# CONSTRUCTION PLANS FOR THE HILLS AT LORSON RANCH FILING NO. 3

## STREET & STORM SEWER CONSTRUCTION PLANS

**THE RIDGE AT LORSON RANCH FIL NO. 3  
STREET & STORM SEWER  
CONSTRUCTION PLANS**

SHEET NUMBER  
 C6.40

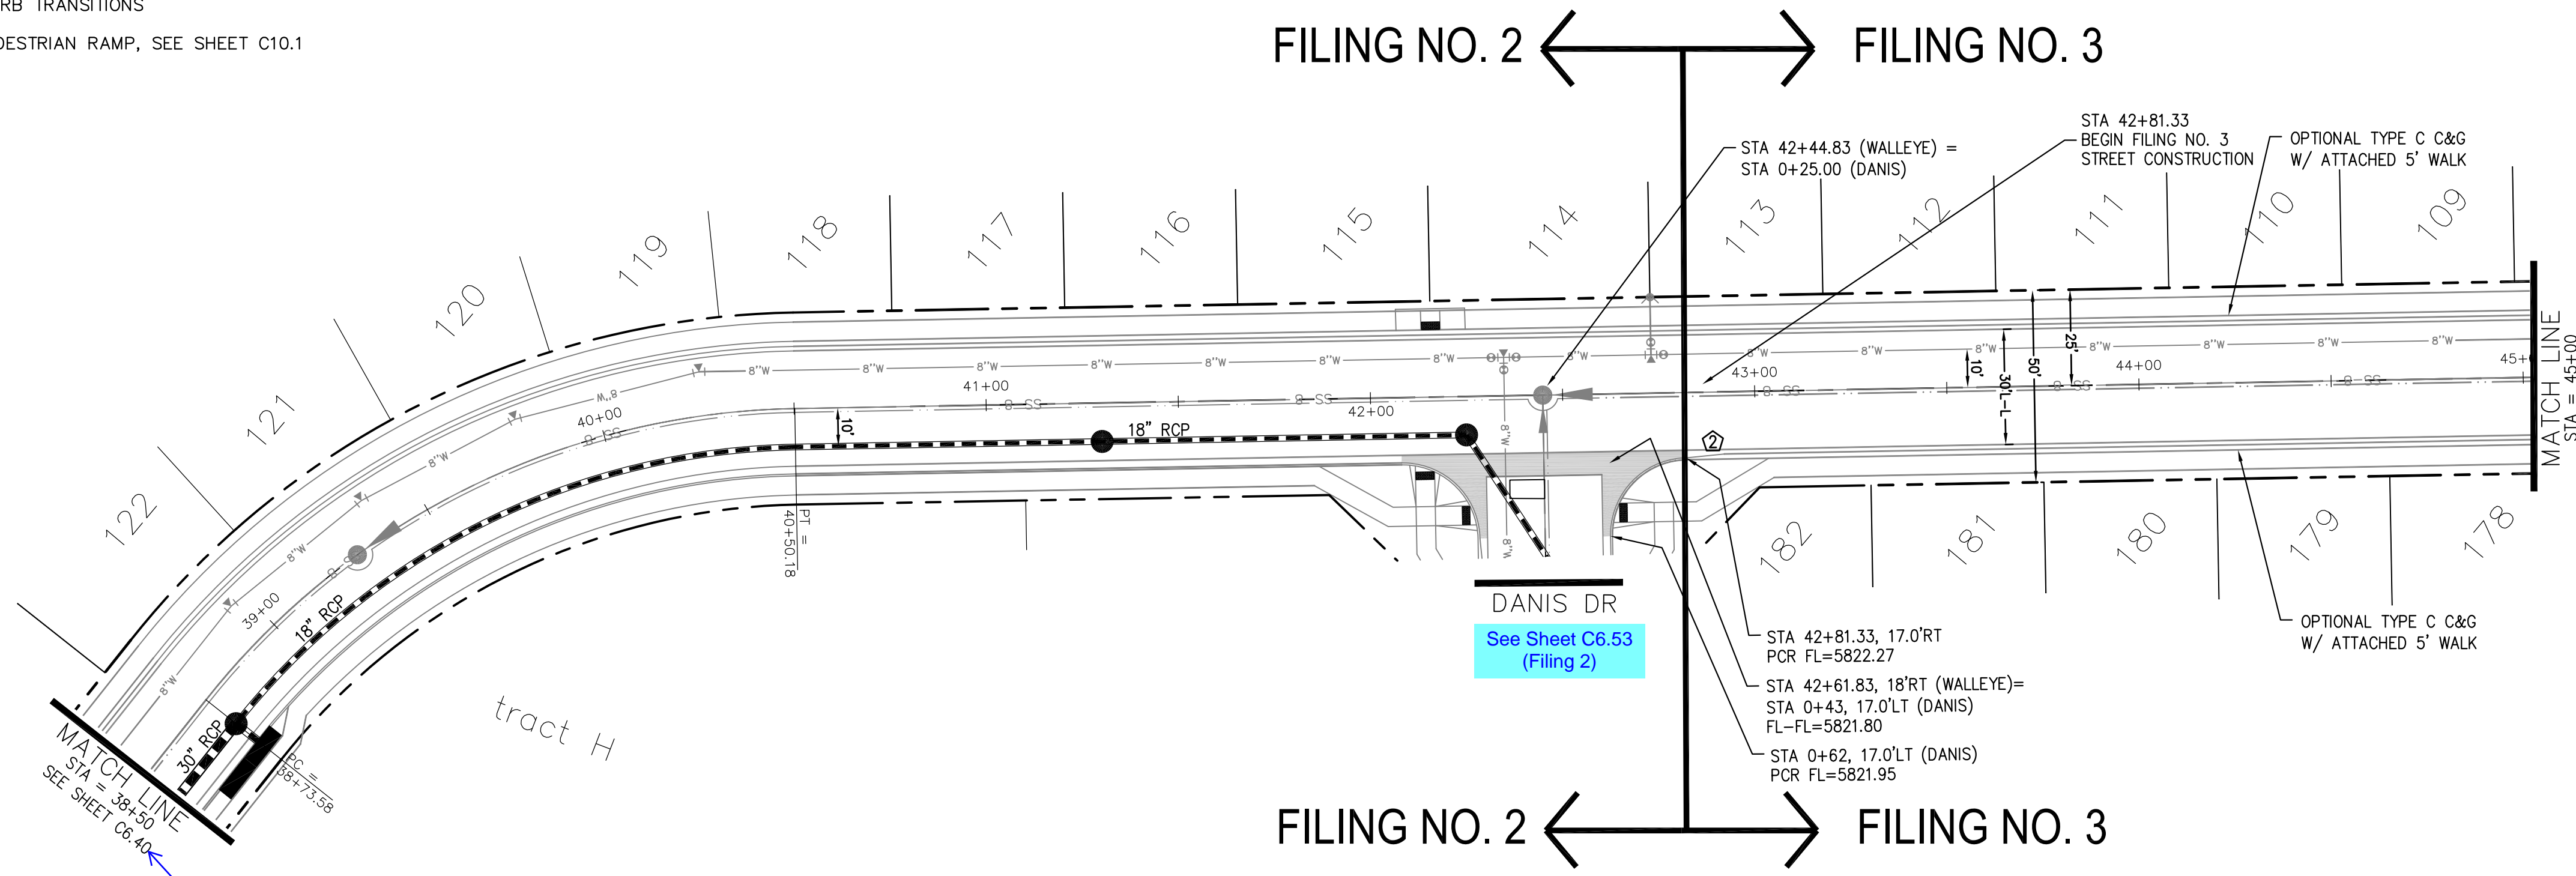
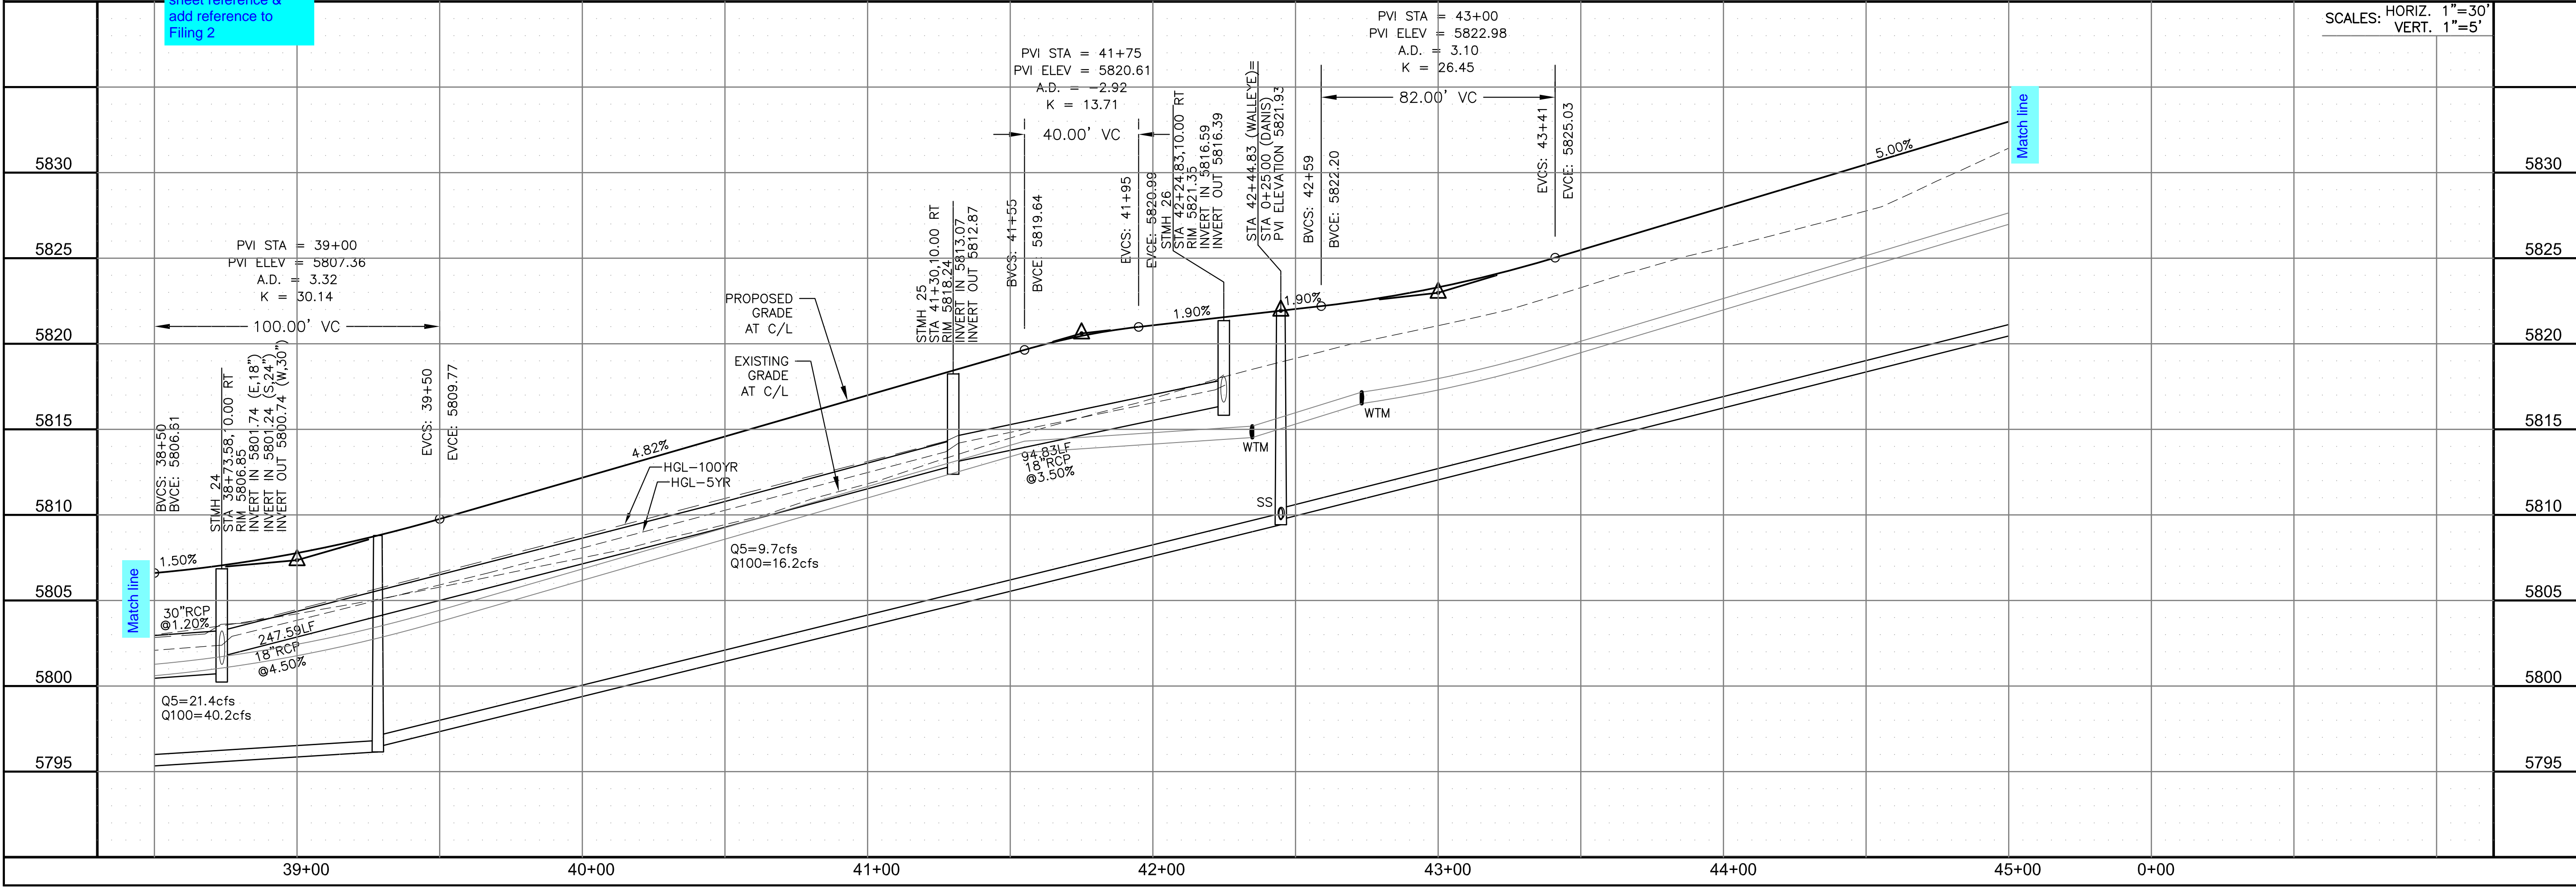
Remove reference to Filing 3

This is sheet C6.40. Update to correct sheet reference & add reference to Filing 2

DATE: NOV, 2021  
 PROJECT NO. 100.068  
 SHEET NUMBER C10.2  
 TOTAL SHEETS: 18

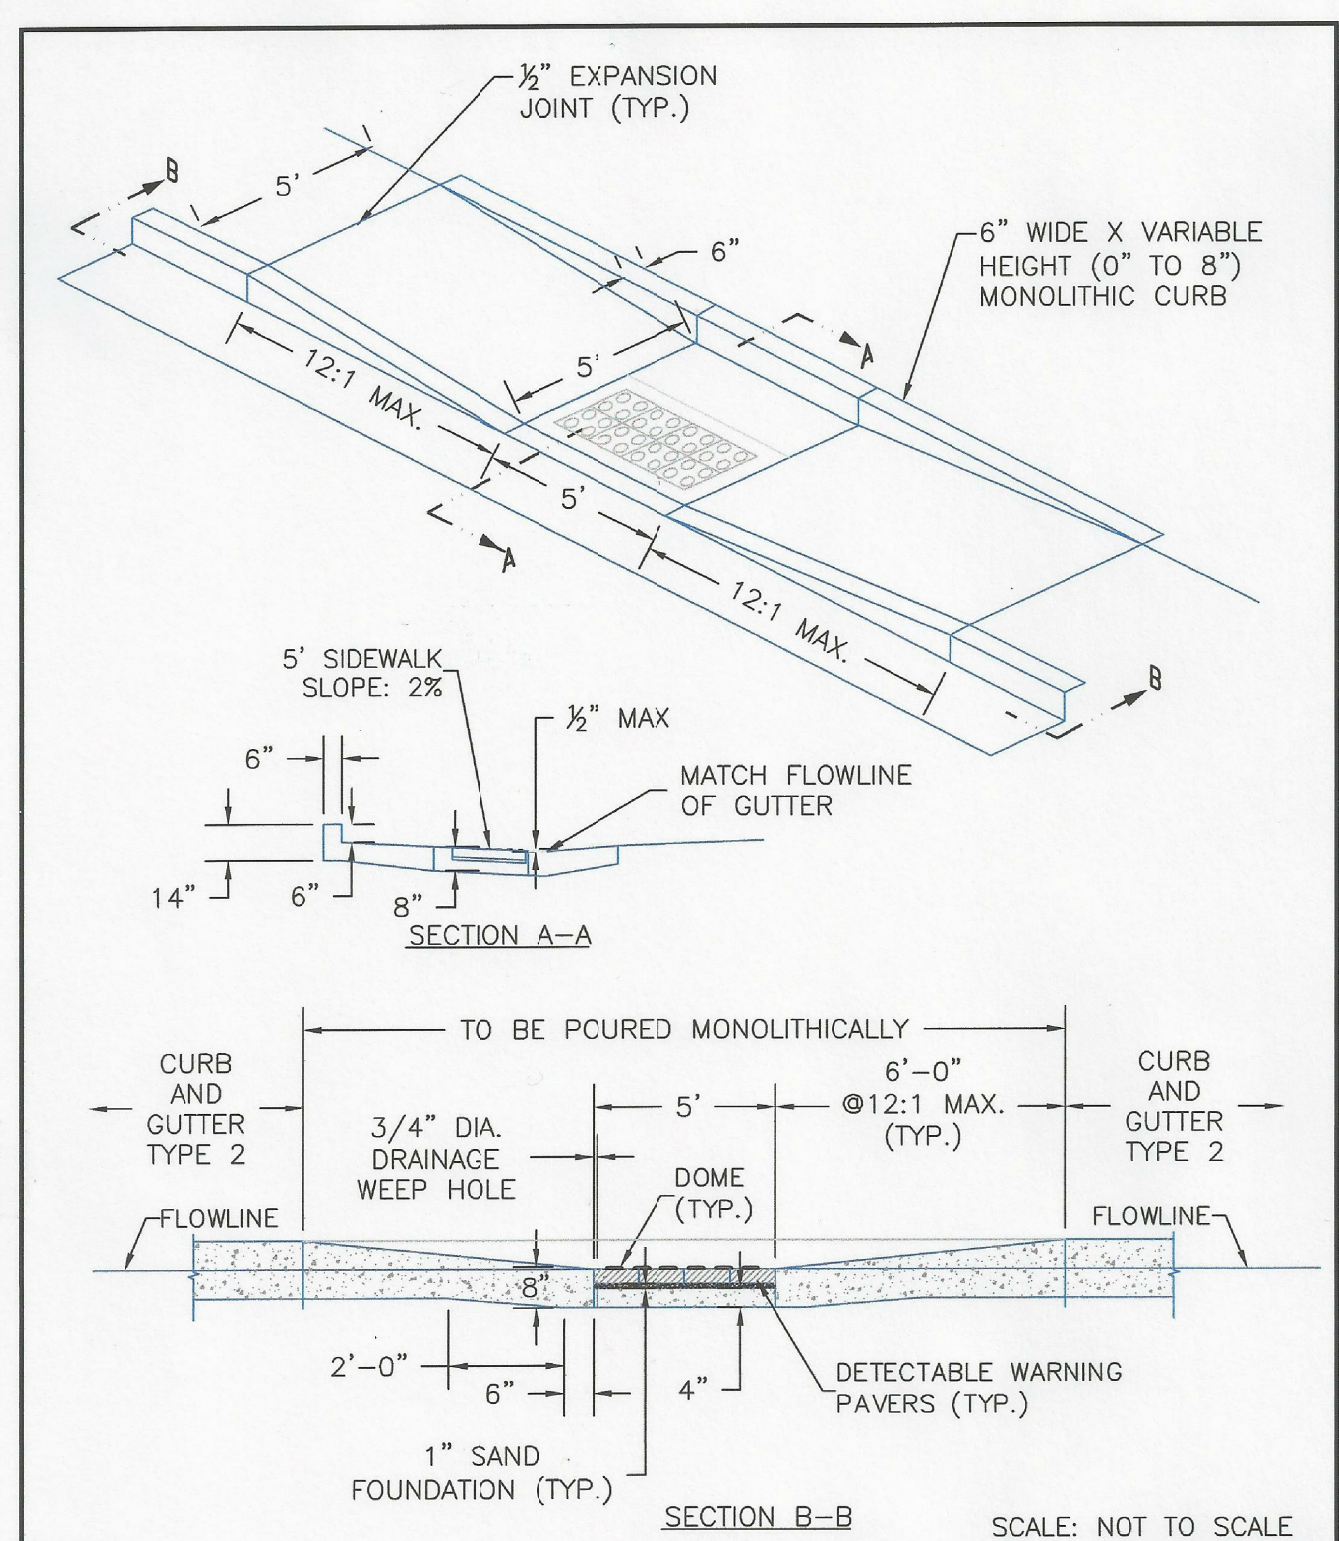
Update with new parallel ped ramp detail dated 6/23/20
